Model	CSO-α (USA only)	Date of Modification
Modified Article	PCB-FCU	Expected Date
Reason for Modification	<input type="checkbox"/> Parts catalog correction <input type="checkbox"/> Vender change To disable installing the memory card on CSO-α <input type="checkbox"/> To meet standartds () <input type="checkbox"/> Part standardization <input type="checkbox"/> To facilitate assembly <input type="checkbox"/> To increase reliability <input checked="" type="checkbox"/> Other	Execution Date
		From 1st mass production of January '92

MODIIFICATION BULLETIN NO. CSO-002

ISSUED ON March 26th, 1992

MODIFICATION BULLETIN NO. CSO-003

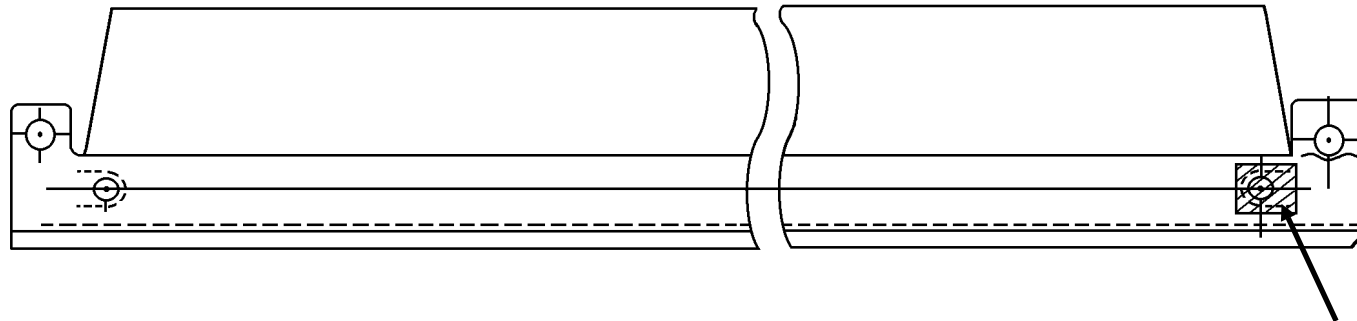
Model	CSO	Date of Modification
Modified Article	Development unit	Exection Date
Reason for Modification	<input type="checkbox"/> Parts catalog correction <input type="checkbox"/> To meet standards () <input type="checkbox"/> To facilitate assembly <input type="checkbox"/> Vender change <input type="checkbox"/> Part standardization <input checked="" type="checkbox"/> To improve reliability <input type="checkbox"/> Other <ul style="list-style-type: none"> • To protect toner from spilling out from the development unit, when moving a machine. • The sponge for the duct will be added, and the sponge pads will be attached on the development unit (Refer to RTB CSO-006). 	1st production of March '92

Development Blade (H0812413)

H0812484: Sponge - Development Blade Holder

MODIFICATION BULLETIN NO. CSO-017ISSUED ON October 9th, 1992.

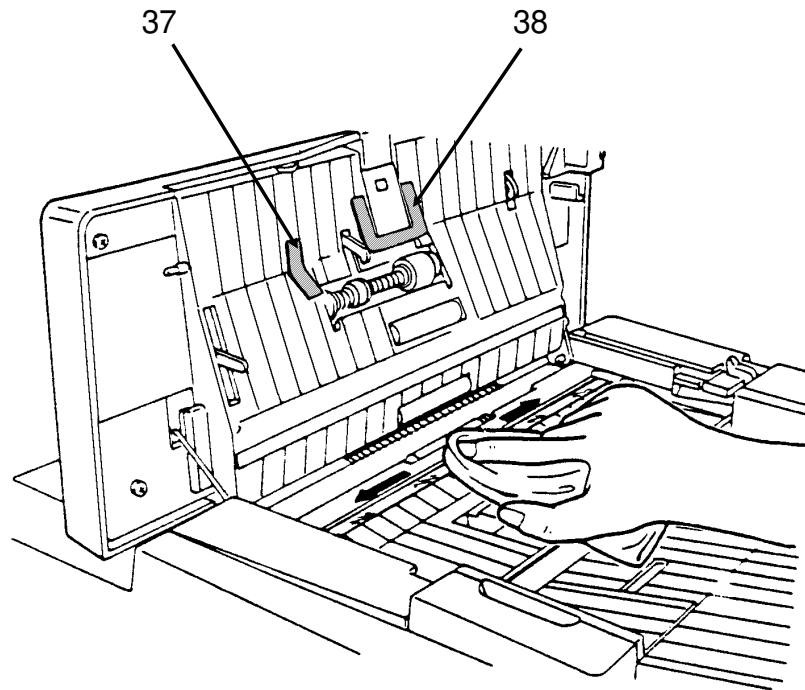
Model	CSO All models	Date of Modification
Modified Article	Shutter Guide	Expected Date
Reason for Modification	<input type="checkbox"/> Parts catalog correction <input type="checkbox"/> To meet standards () <input type="checkbox"/> To facilitate assembly <input type="checkbox"/> Vender change <input type="checkbox"/> Part standardization <input checked="" type="checkbox"/> To improve reliability <input type="checkbox"/> Other	Execution Date
	<p>In order to improve the 50 sheets ADF capability against USA 20lb papers, we have changed the shutter Guide.</p> <p>Also, the index nos of H0811129/H0811160 were incorrect.</p> <p>H0811129: Index No. 5-37 → 5-38</p> <p>H0811160: Index No. 5-38 → 5-37</p>	<ul style="list-style-type: none"> • From the 1st production of Jun '92 (Except the following models.) • H081-22 6112260226~ • H081-28 L4020602351~ • H081-29 L4120602051~ • H081-59 6022260231~

MODIFICATION BULLETIN NO. CSO-030ISSUED ON March, 9th, 1993

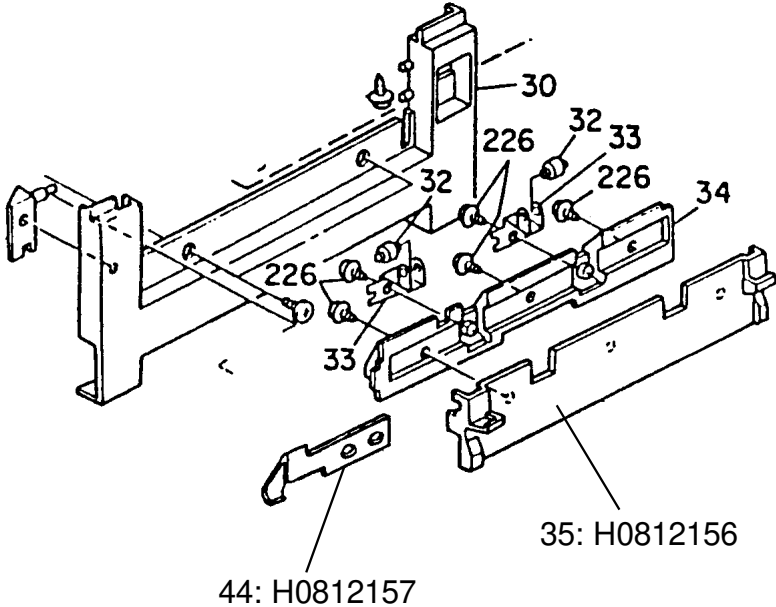
Model	All models	Date of Modification
Modified Article	Paper Exit Cover	Expected Date
Reason for Modification	<div><div><div><input type="checkbox"/> Parts catalog correction</div><div><input type="checkbox"/> Vender change</div></div><div><div><input type="checkbox"/> To meet standards ()</div><div><input type="checkbox"/> Part standardization</div></div><div><div><input checked="" type="checkbox"/> To facilitate assembly</div><div><input type="checkbox"/> To improve reliability</div><div><input type="checkbox"/> Other</div></div></div> <p>In order to facilitate assembly, the spring plate (H0812157) has been separated from the paper exit cover (H0812156). (At present, the spring plate is attached to the paper exit cover)</p>	From Oct., of '92 production
		Execution Date

MODIFICATION BULLETIN NO. CSO-033ISSUED ON March 24th, 1993.

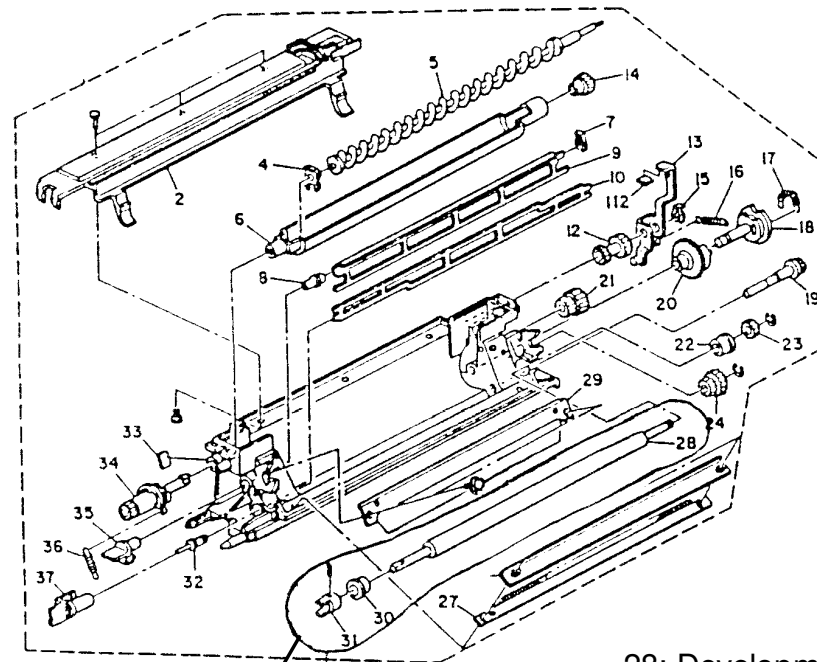
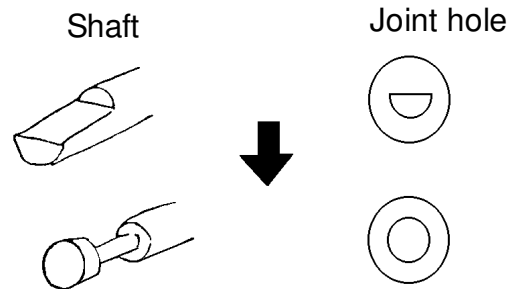
Model	CSO All models	Date of Modification
Modified Article	Development Unit	Expected Date
Reason for Modification	<input type="checkbox"/> Parts catalog correction <input type="checkbox"/> To meet standards () <input type="checkbox"/> To facilitate assembly <input type="checkbox"/> Vender change <input type="checkbox"/> Part standardization <input type="checkbox"/> To improve reliability Other	Execution Date
		From the Feb. production.
The development roller and the Joint - development roller have been combined to one part, in order to facilitate servicing.

MODIFICATION BULLETIN NO. CSO-036ISSUED ON March 25th, 1993

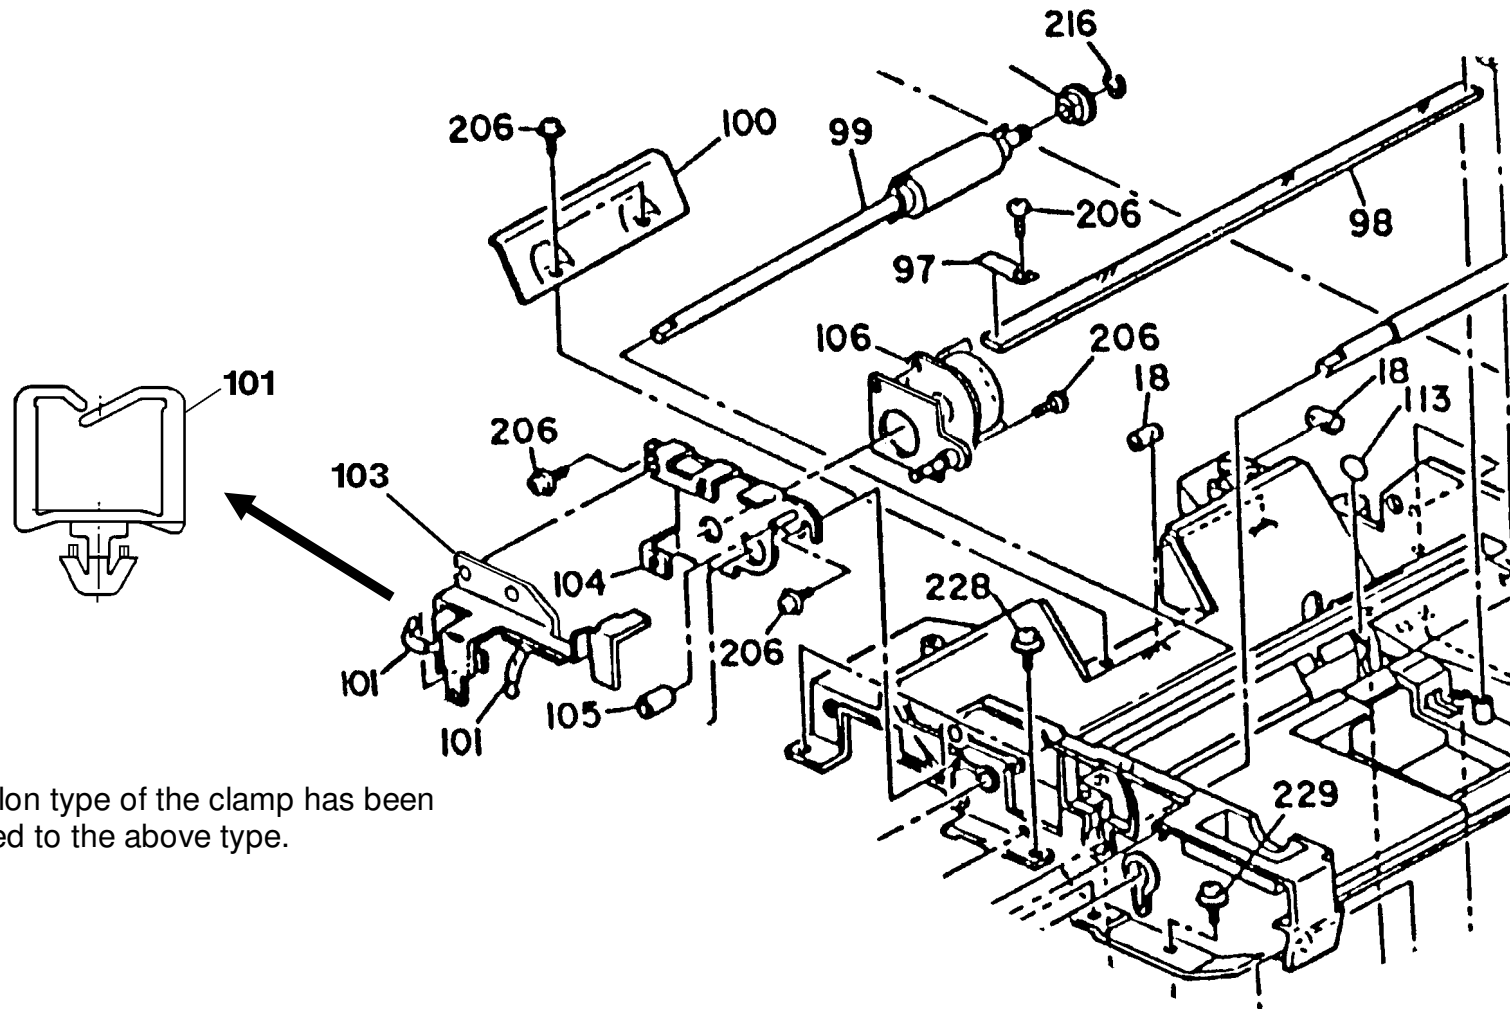
Model	CSO All models	Date of Modification
Modified Article	Various	Expected Date
Reason for Modification	<input type="checkbox"/> Parts catalog correction <input type="checkbox"/> To meet standards () <input checked="" type="checkbox"/> To facilitate assembly <input type="checkbox"/> Vender change <input checked="" type="checkbox"/> Part standardization <input type="checkbox"/> To improve reliability <input type="checkbox"/> Other	After the old parts have become out of stock.
		Execution Date
	1. Antistatic Brush - Part standardization 2. MDF Bracket - To facilitate assembly, the clamp has been combined with the MDF bracket. 3. Harness clamp/ Guide - To facilitate assembly, the clamp has been changed as shown on the next page. (refer to the attachment)

MODIFICATION BULLETIN NO. CSO-040ISSUED ON March 25th, 1993

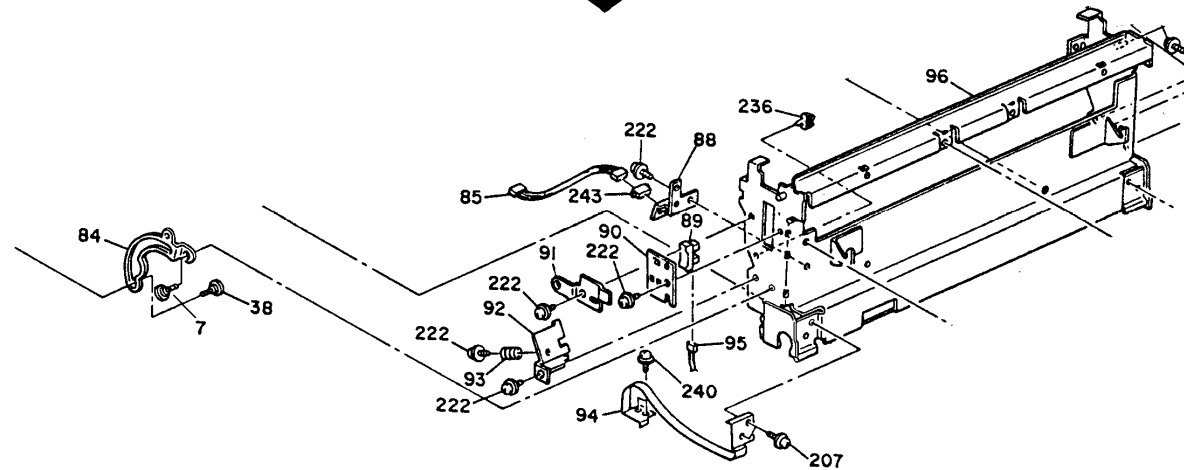
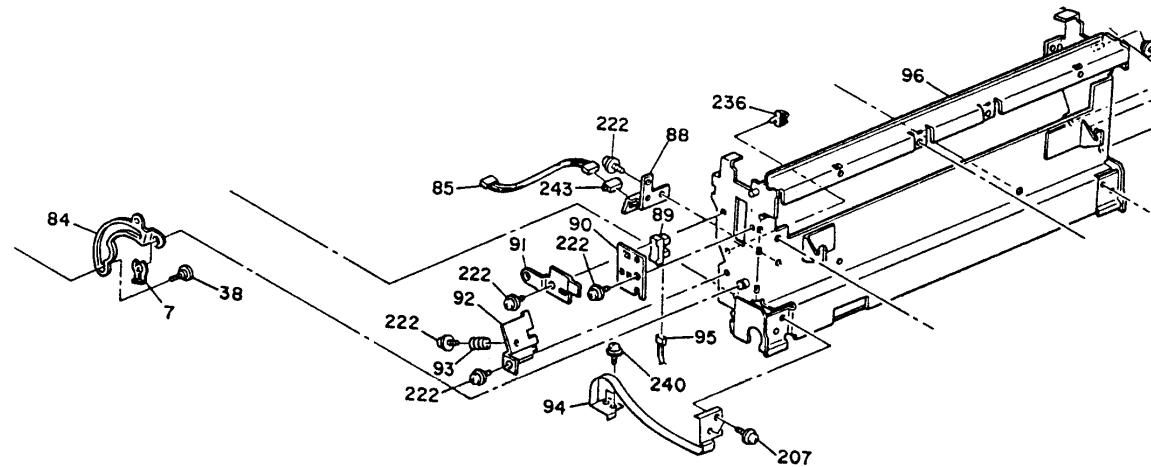
Model	CSO	Date of Modification
Modified Article	Side Plate - Copy Out	Expected Date
Reason for Modification	<input type="checkbox"/> Parts catalog correction <input type="checkbox"/> To meet standards () <input checked="" type="checkbox"/> To facilitate assembly <input type="checkbox"/> Vender change <input type="checkbox"/> Part standardization <input type="checkbox"/> To improve reliability <input type="checkbox"/> Other	From Oct. of '92 production
		Execution Date
To facilitate assembly, a stepped screw has been used instead of the snap ring. Because of the above change, the copy out side plate has been changed. These parts should be replaced at the same time.

MODIFICATION BULLETIN NO. CSO-041

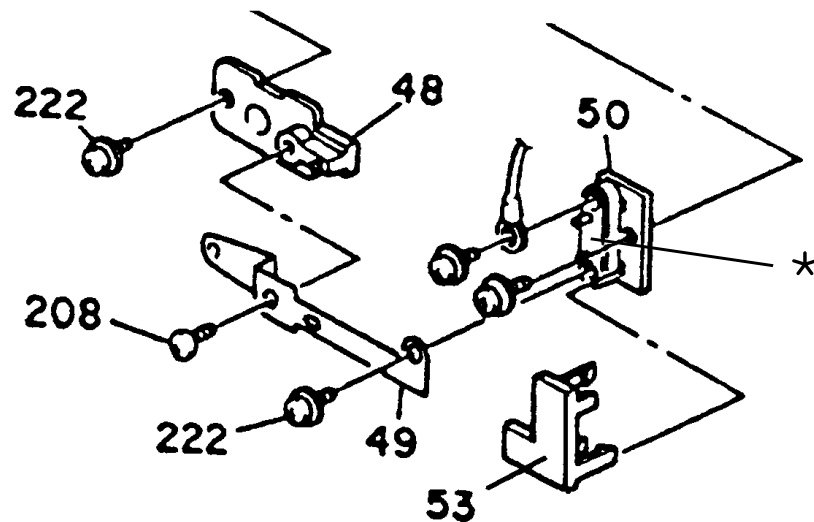
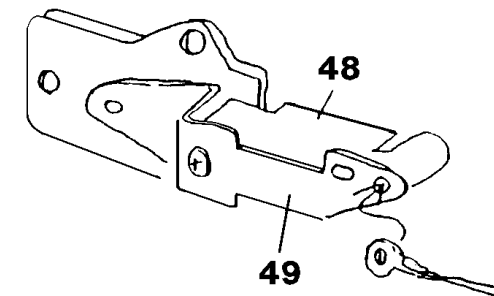
Model	CSO	Date of Modification
Modified Article	Bias Terminal	Expected Date
Reason for Modification	<input type="checkbox"/> Parts catalog correction <input type="checkbox"/> To meet standards () <input checked="" type="checkbox"/> To facilitate assembly <input type="checkbox"/> Vender change <input type="checkbox"/> Part standardization <input type="checkbox"/> To improve reliability <input type="checkbox"/> Other	From Jan of '93 production
		Execution Date
* H0813260, H0813261, H0813174, H0813172 and H0813121 should be replaced at the same time with H0813266 and H0813267.

48: H0813260 Development Bias Bushing
 49: H0813261 Development Bias Terminal
 50: H0813171 Bias Terminal
 53: H0813174 Left Cover - Bias Terminal
 * : H0813121 Bias Terminal Plate (Page 1-11, index
 no.50)

MODIFICATION BULLETIN NO. CSO-044

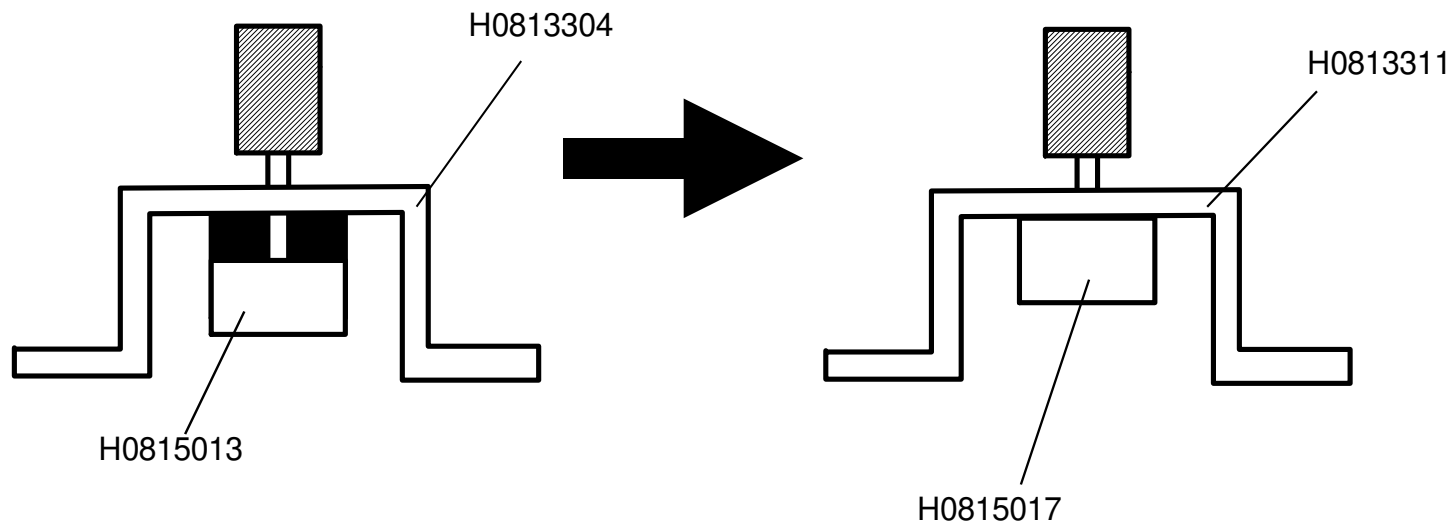
Model	CSO	Date of Modification
Modified Article	Paper Feed Motor	Expected Date
Reason for Modification	<input type="checkbox"/> Parts catalog correction <input type="checkbox"/> To meet standards () <input type="checkbox"/> To facilitate assembly <input type="checkbox"/> Vender change <input checked="" type="checkbox"/> Part standardization <input type="checkbox"/> To improve reliability <input type="checkbox"/> Other	From Jan. of '93 production
		Execution Date
These parts should be replaced at the same time.

MODIFICATION BULLETIN NO. CSO-046ISSUED ON March, 29th, 1993

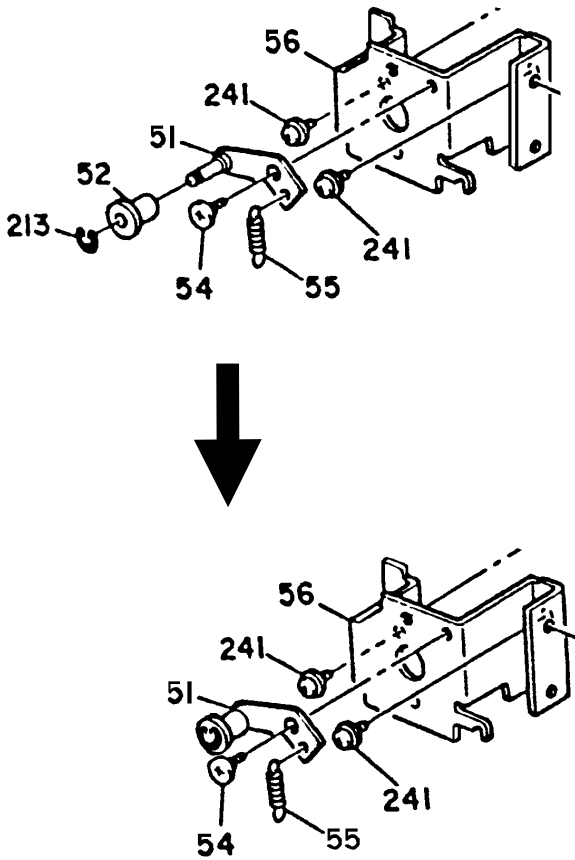
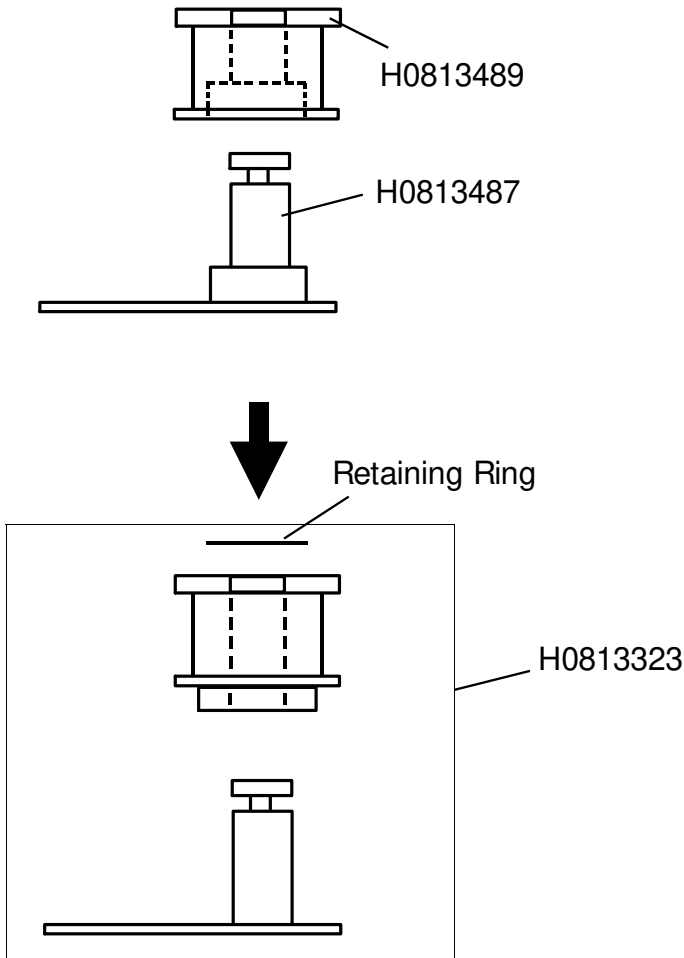
Model	CSO	Date of Modification
Modified Article	Tension Roller	Expected Date
Reason for Modification	<input type="checkbox"/> Parts catalog correction <input type="checkbox"/> To meet standards () <input type="checkbox"/> To facilitate assembly <input type="checkbox"/> Vender change <input type="checkbox"/> Part standardization <input type="checkbox"/> To improve reliability <input checked="" type="checkbox"/> Other	From Jan. of '93 production
		Execution Date
We will combine the Tension Roller and the Tension Roller Bracket in order to facilitate servicing.

MODIFICATION BULLETIN NO. CSO-047

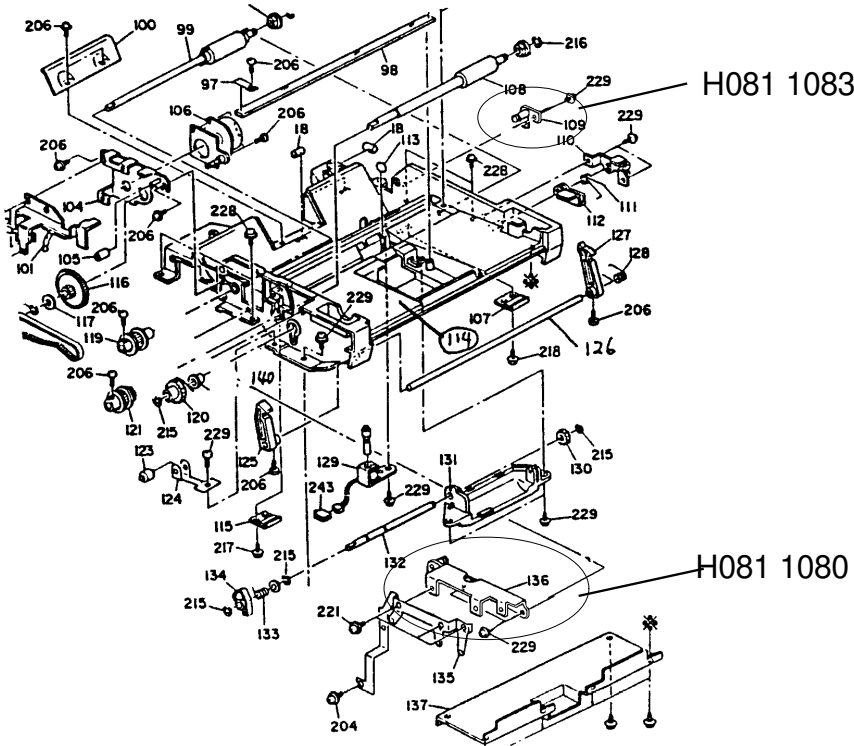
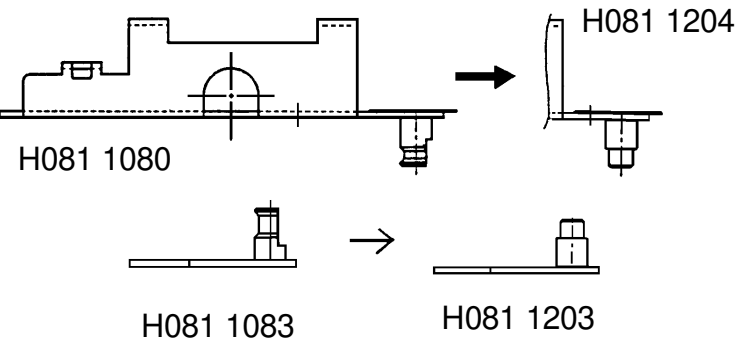
Model	CSO All models	Date of Modification
Modified Article	Fulcrum Bracket	Expected Date
Reason for Modification	<input type="checkbox"/> Parts catalog correction <input type="checkbox"/> To meet standards () <input type="checkbox"/> To facilitate assembly <input type="checkbox"/> Vender change <input checked="" type="checkbox"/> Part standardization <input type="checkbox"/> To improve reliability <input type="checkbox"/> Other	From Feb. productions
		Execution Date
H081 1083/ 1080: Refer to attachment H081 1150/ 1152: To standardize the parts with other versions.

MODIFICATION BULLETIN NO. CSO-048ISSUED ON April 8, 1993

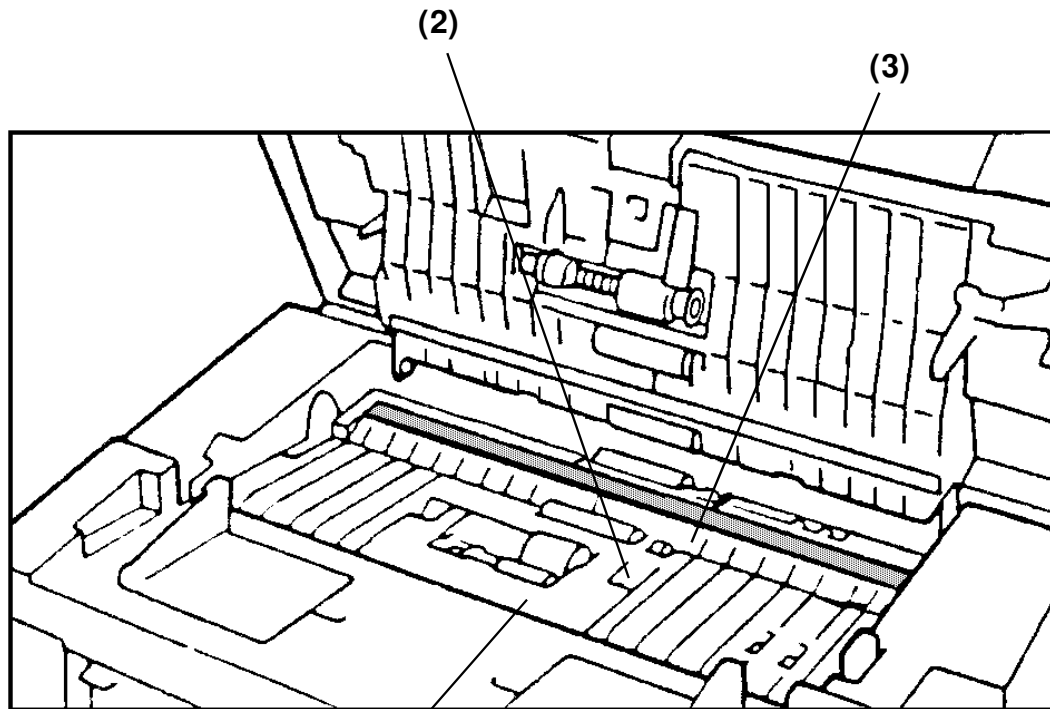
Model	CSO All models	Date of Modification
Modified Article	Lower Document Guide	Expected Date
Reason for Modification	<input type="checkbox"/> Parts catalog correction <input type="checkbox"/> To meet standards () <input checked="" type="checkbox"/> To facilitate assembly <input type="checkbox"/> Vender change <input checked="" type="checkbox"/> Part standardization <input type="checkbox"/> To improve reliability <input type="checkbox"/> Other	From Feb. productions.
		Execution Date
We have deleted the maintenance decals, and instead, on the lower document guide, we have added cut down marks. Also, the dust shield sheet has been combined with the document guide.
